Council Reference: DA25/0628
Your Reference: SSD-41110128

47 place residential aged care accommodation, 51 independent living units split across 3 buildings, bowling green, indoor swimming pool and spa and associated facilities (SSD-41110128) at Lot 1 DP 786570; 87 – 89 Tweed Coast Road, HASTINGS POINT (DA25/0628)

Reference is made to the above proposal and the Department's request for Council's advice/comment on the proposed development.

Figure 4: Extract of typical "Type 2" unit with Multipurpose Room highlighted yellow

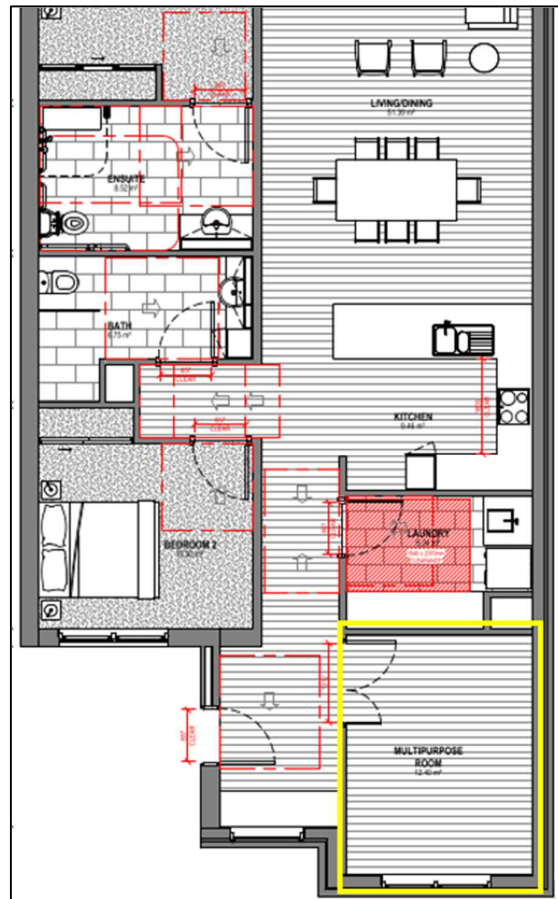
Buildings E, F, and G result in potential separation issues. Insufficient separation appears to occur between multi-purpose rooms, living rooms, and balconies. Further information is required in relation to the use of these multi-purpose rooms to determine if they are capable of being used as habitable rooms.

The following separation issues are raised:

Figure 5: Extract of Building E plan with example of window to corridor highlighted yellow

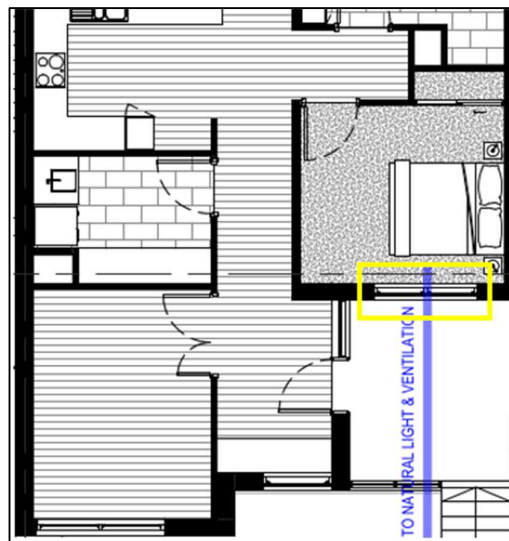
Buildings E, F and G contain units, which have windows to habitable rooms that face into enclosed corridors. The glazing and sliding doors on the corridor restrict the natural daylight and ventilation to these rooms.

It is further noted that the internal units of buildings E, F and G contain an open plan living, dining and kitchen layout that exceeds 8m from an external window. The distance from an external window which results in further reductions in the amount of natural light and breezes available internally.
